Product Change Notice (PCN)

Subject: Assembly materials change for RL78 family LQFP package products.

Difference of specification (RL78 family LQFP products) 12x12mm 0.65mm pitch 64pin

MCP-AB-22-0011
PC-MCU-A002A/E

Difference outline

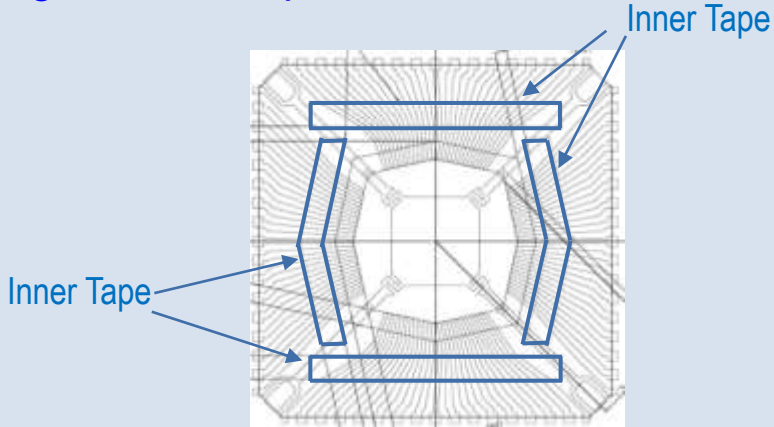
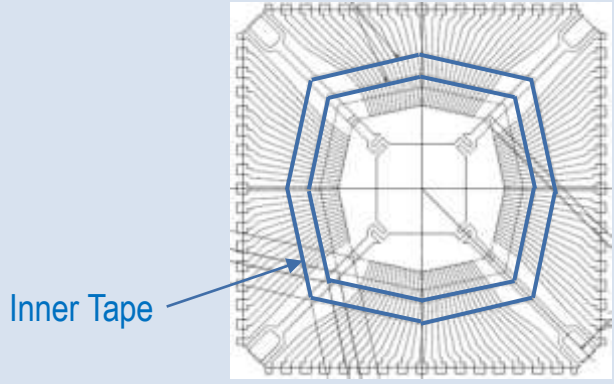
- Difference point
Assembly material: Inner tape design of lead frame
 - Specification and characteristics of product:
No change
 - Quality and reliability
No change
